CITY PLAN COMMISSION STAFF REPORT

Project Name
1901 Locust Townhomes

Request
CD-CPC-2023-00096
Development Plan

Docket #3 Approval with Conditions

1 LANDSCAPE PLAN
1" = 10'

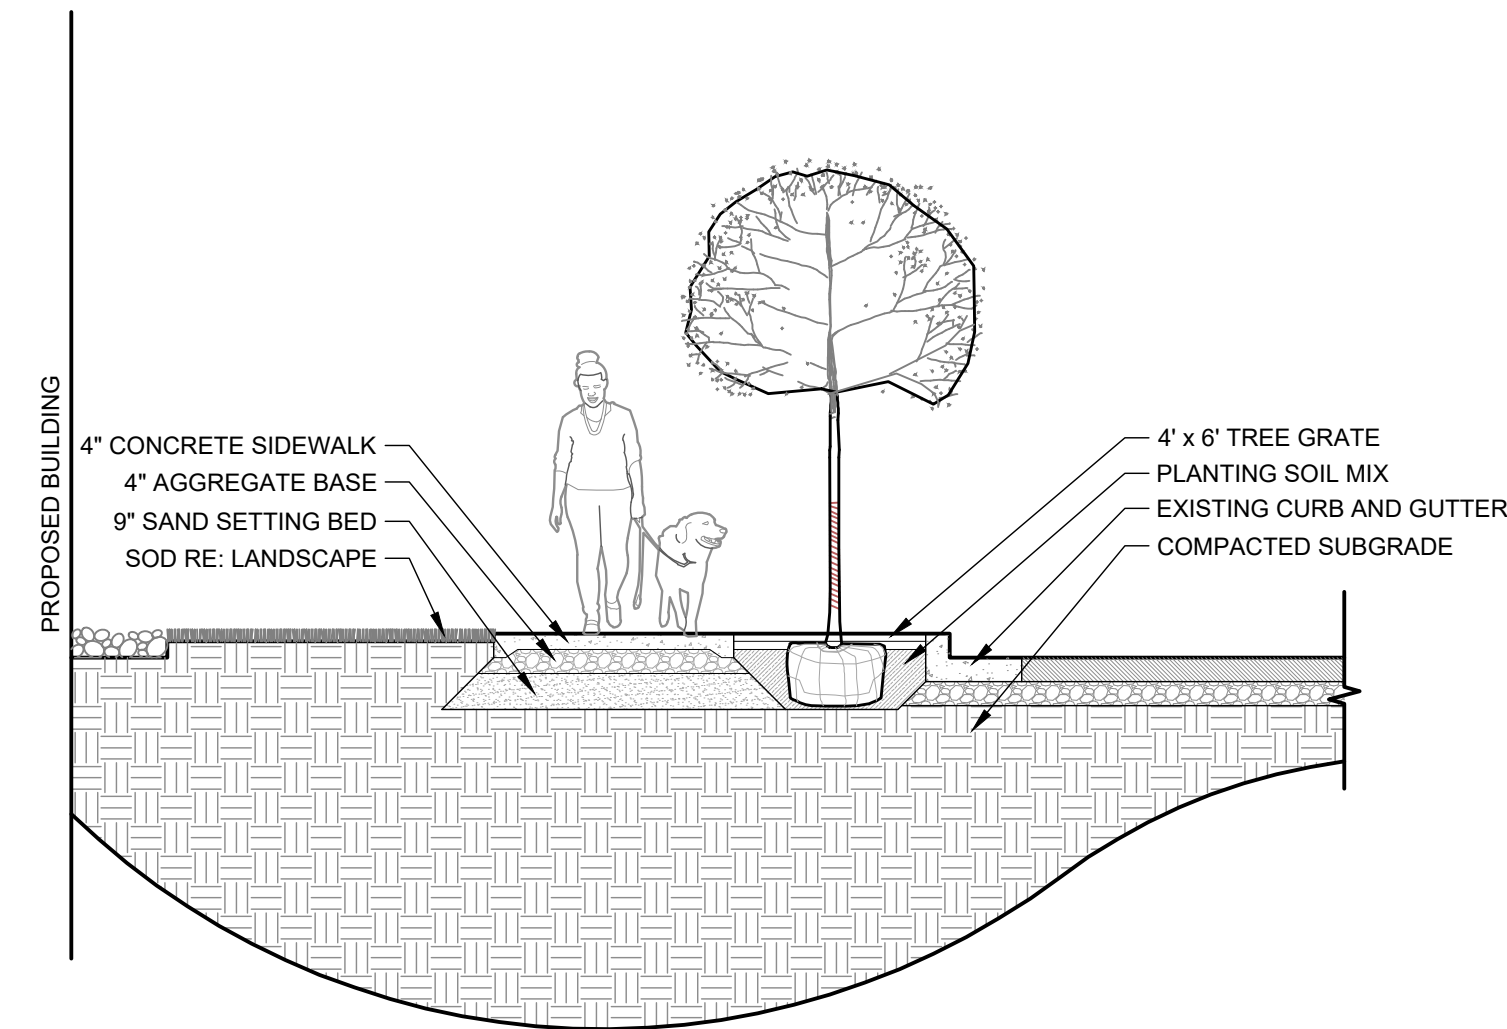
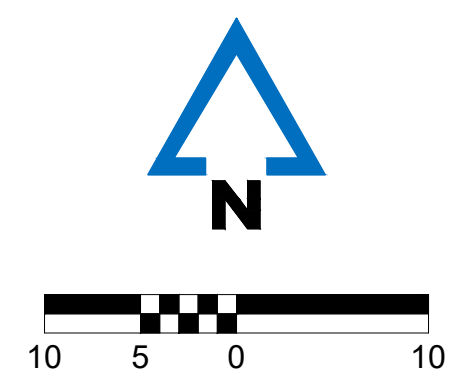
The developer has proposed landscaping in compliance with the Zoning and Development Code. There are four trees along 19th Street and Fescue Sod along the outside of both buildings. Locust Street was vacated in 1995 and is currently a private street. The landscaping along Locust street has been in place for a few years and will remain. The developer is providing an additional tree on the southeast corner in lieu of an additional tree on Locust Street.

7. The developer shall revise the landscaping plan to include additional native landscaping materials and confirm the proposed ground cover is compliant with Section 88-425-10-D of the Zoning and Development Code prior to ordinance request.

EXTERIOR
ELEVATIONS -
WEST BUILDING

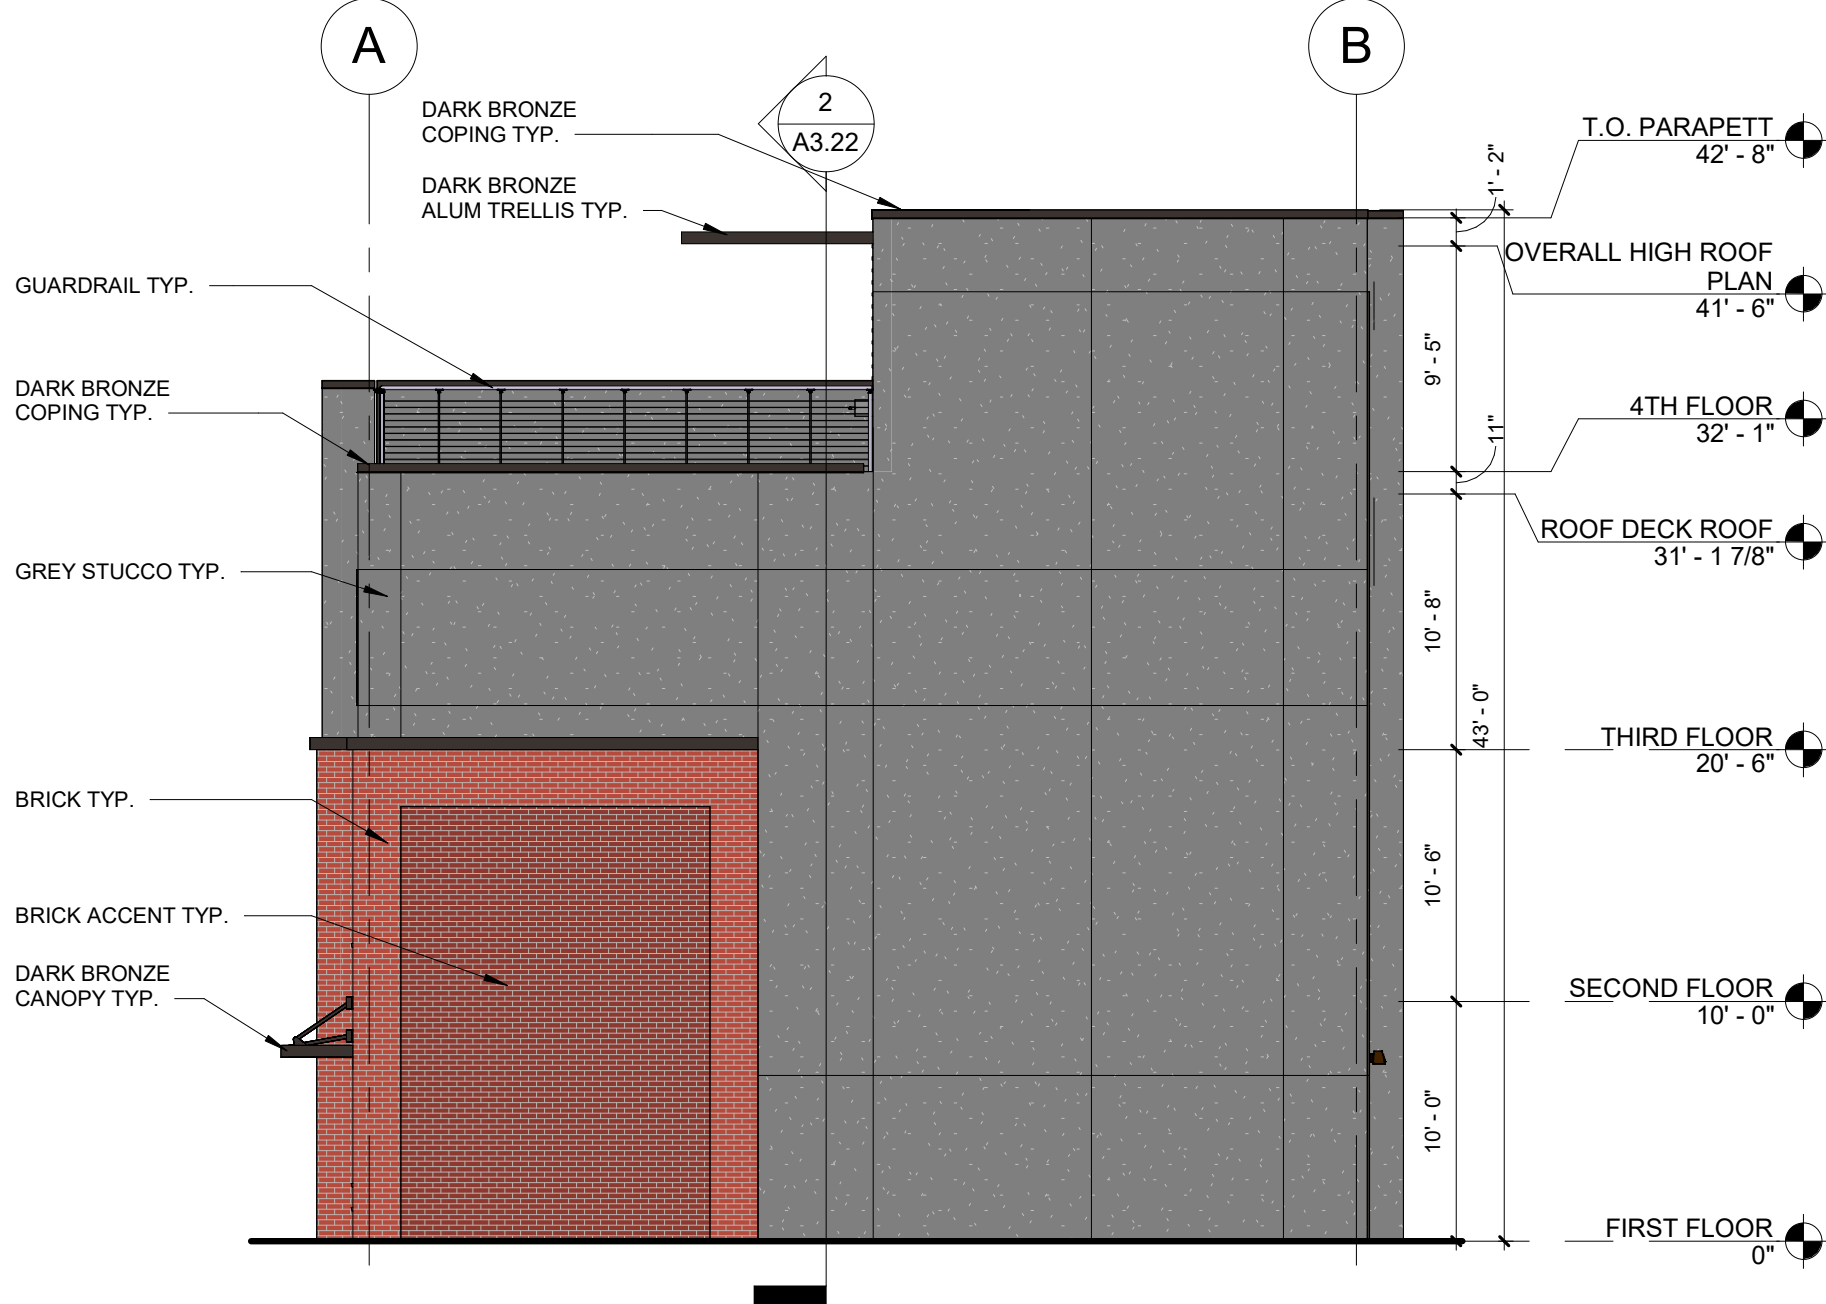
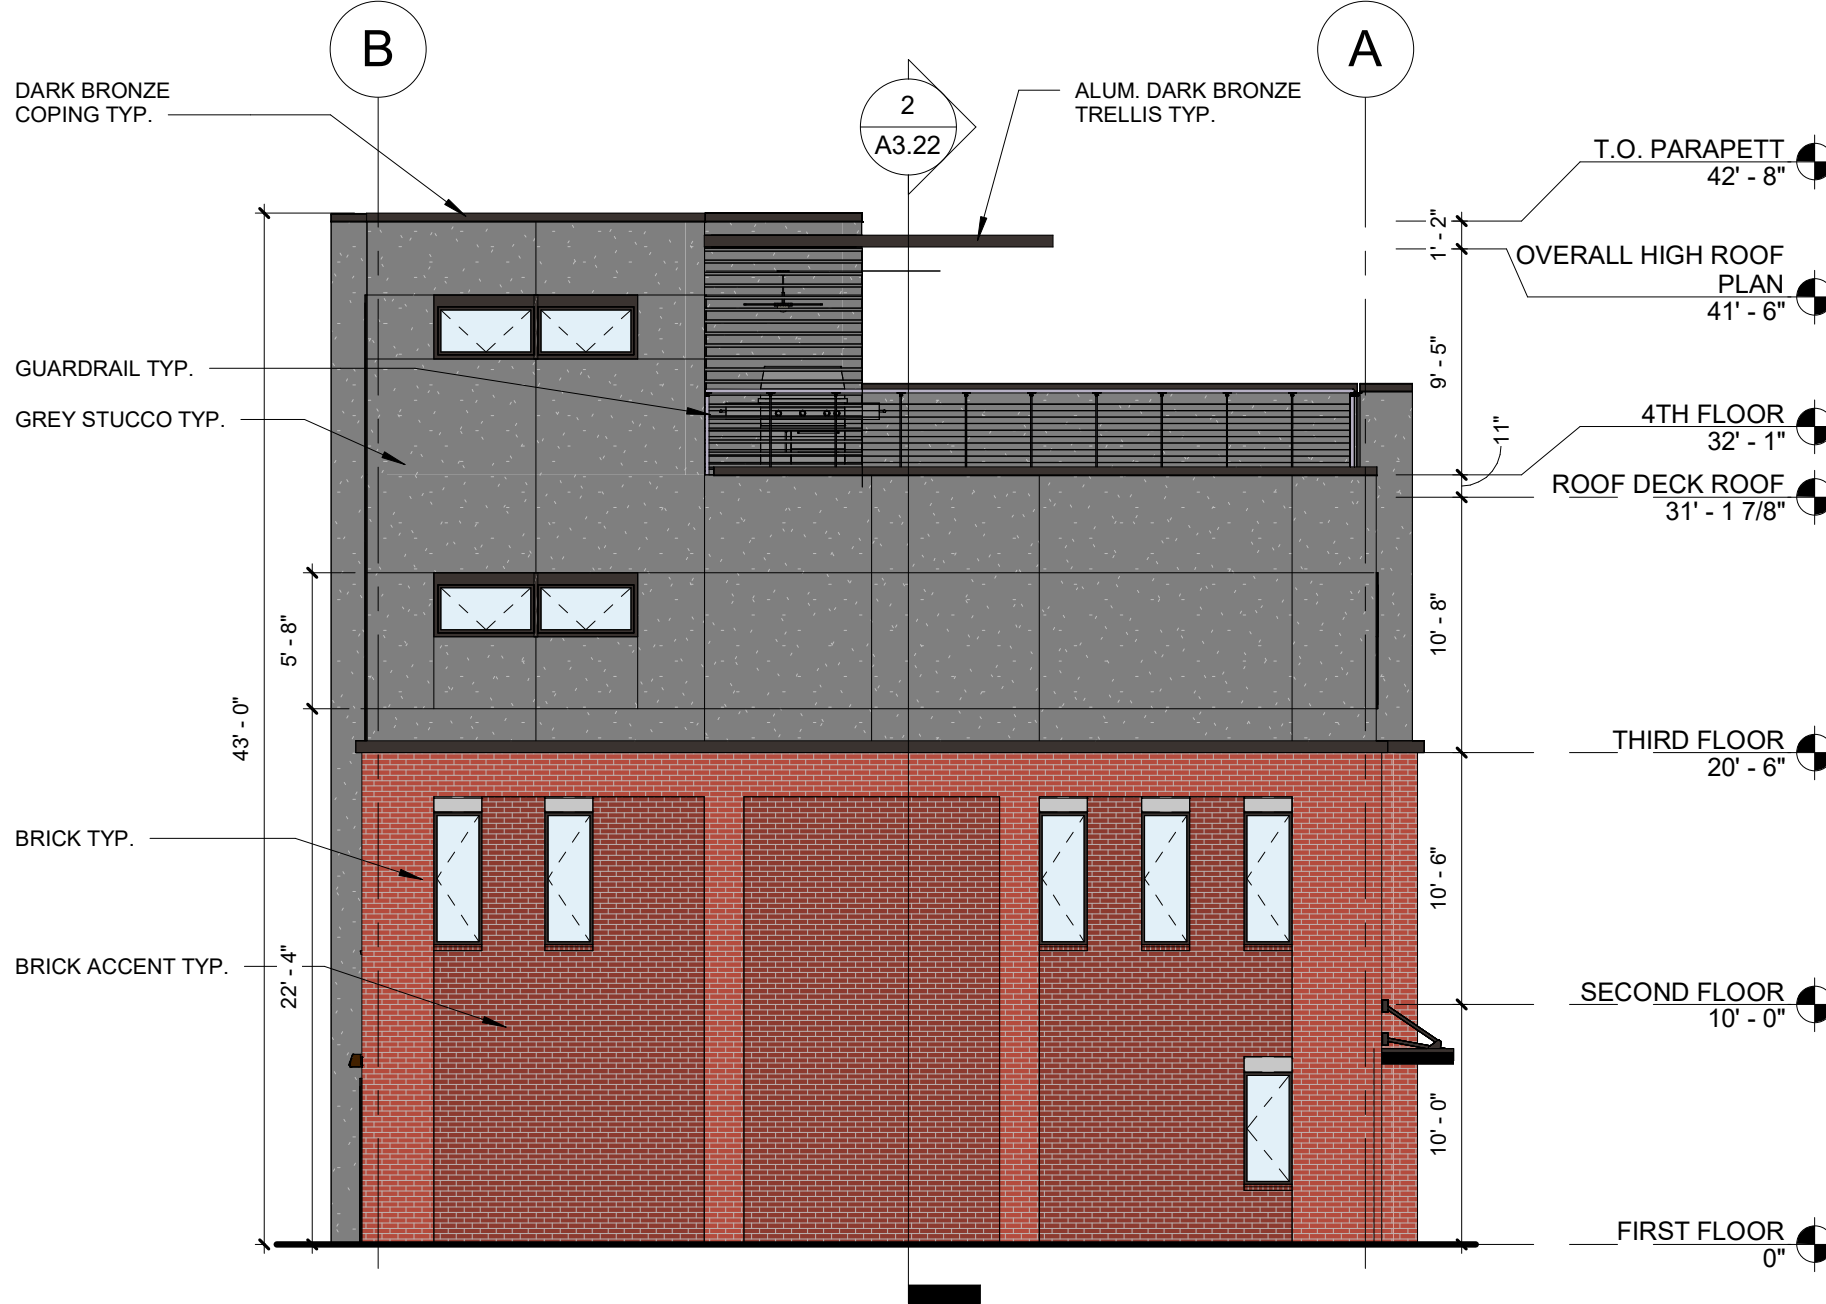
Brick is a high quality construction material, however the amount of stucco and the overall design of both structures needs improvement. The southern elevations of both buildings show a large amount of stucco directly facing an existing residential structure, more windows, architectural detailing, and architectural variation need to be provided. Nineteenth street is a prominent street in the Crossroads

area, so the architecture will need to more closely match the development to the West to create a more cohesive streetscape. The northern elevations of both structures also show a large amount of stucco facing 19th Street and the architectural design will need to include additional windows or a façade that mimics the entryway to a building. Additionally, the interior of the development needs to create a more welcoming environment for the residents. The interior facing walls of the development should more closely match the exterior facing walls with the added material changes, a reduction in the amount of stucco is also requested by staff.

5. Signage was not reviewed with this submittal, all signage shall conform to 88-445 and shall require a sign permit prior to installation.
6. The proposed development has too many blank walls throughout the project, the developer shall submit revised elevations showing an increase in architectural fenestration, variety in construction materials and/or proposed locations for murals on the northern, southern, and interior facades of both buildings to better match the surrounding area prior to ordinance request.
